UNITED STATES PATENT AND TRADEMARK OFFICE

APPLICATION NO.	FILING DATE	FIRST NAMED INVENTOR	ATTORNEY DOCKET NO.	CONFIRMATION NO.
18/698,915	04/05/2024	Tetsu MORISHIMA	228963	3163

Office Action Summary	Application No. 18/698,915	Applicant(s) MORISHIMA et al.	
	Examiner Eric K Wong	Art Unit 2874	AIA (First Inventor to File) Status Yes

DETAILED ACTION

Fig.11

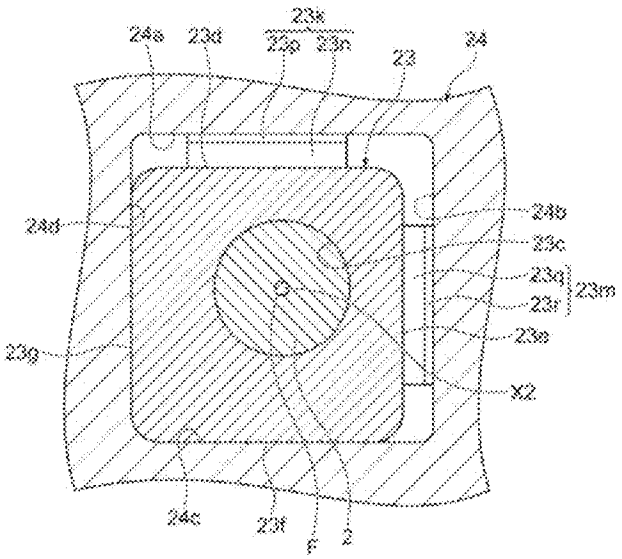
- an elastic member (5) that biases the flange toward the positioning portion,
- wherein the reference surface includes two contact parts (surfaces to the left and right of 23k in figure 11) provided apart from each other by a predetermined distance (the area bounded by spring 23k) and restricting a rotational direction of a flange as a result of the planar surface of the flange being brought into parallel contact with the planar surface of the inner wall surface with the planar surface of the flange contacting the two contact parts (when the flange is assembled with the provided spring cutout portion that resides within a channel that creates two contact points, the flange cannot rotate).

As to claim 2, the reference surface has a recessed part (23k) between the two flat reference parts.

As to claim 5, the outer shape of the flange is quadrangular (figure 11).

As to claim 6, an outer portion is curved (unlabeled corners are curved in figure 11).

As to claim 8, the "line" extending along the reference surface coincides with the flange (figure 11).

FIG. 4A

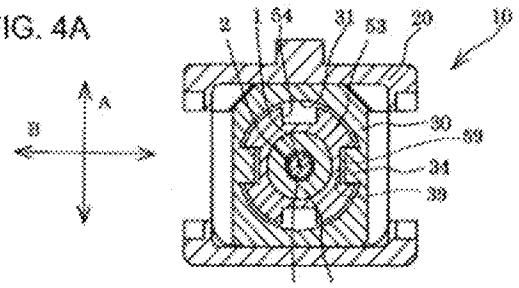
Inagaki discloses such a well known recessed surface with projections (figure 4A).

It would have been obvious to one having ordinary skill in the art to add recessed portions with corresponding projections as taught by Inagaki to lock a flange's spring in Shimikawa in place to prevent misalignment.
